UNION ELECTRIC COMPANY

DOCKET NUMBER 50-483  
CALLAWAY PLANT, UNIT 1  
TECHNICAL SPECIFICATION AFFIRMATION AND PROPOSED FSAR CHANGES

In addition, the attached pages represent differences between the as-built plant and the FSAR. These will be included in the next revision to the FSAR.

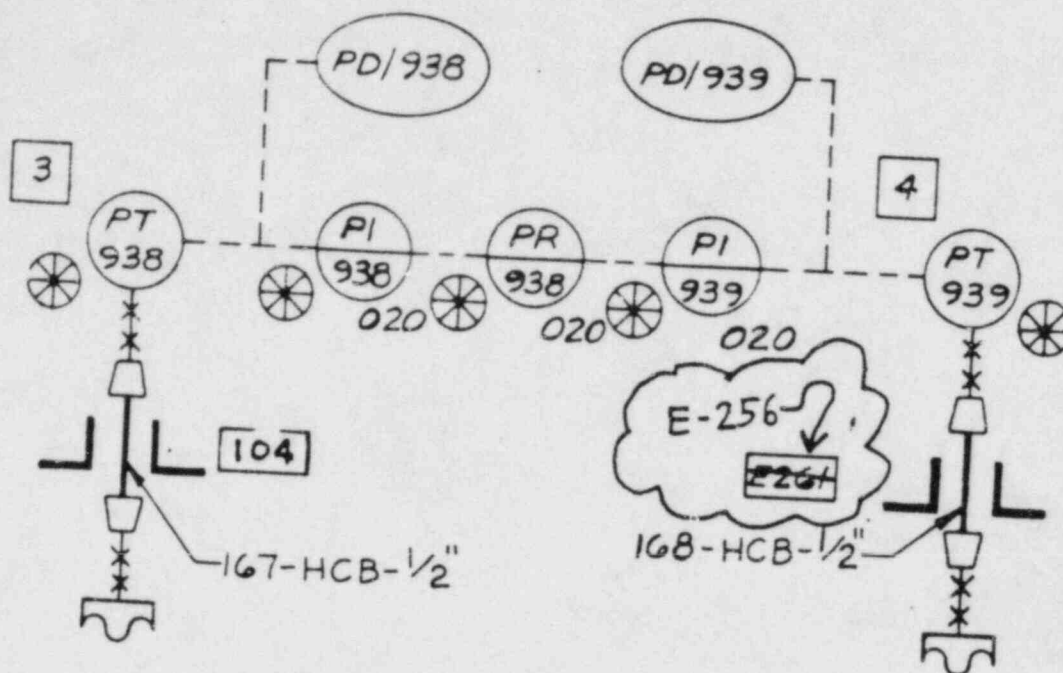
EMERGENCY OPERATION - <sup>downstream</sup> Located in the control building supply system ductwork, ~~upstream~~ of the supply unit, are redundant radiation monitors, ~~redundant chlorine monitors~~, and a smoke detector. These monitors sense contaminants in the influent and alarm in the control room when limits are exceeded. The high radiation and chlorine monitors (chlorine concentrations of 5.0 ppm or greater) initiate isolation of the control building normal supply and exhaust systems. The chlorine monitors comply with the requirements of Regulatory Guide 1.78, as discussed in Table 6.4-1. Chlorine monitors are not required for the Callaway plant per Section 2.2.3.1.3 of the Callaway Site Addendum.
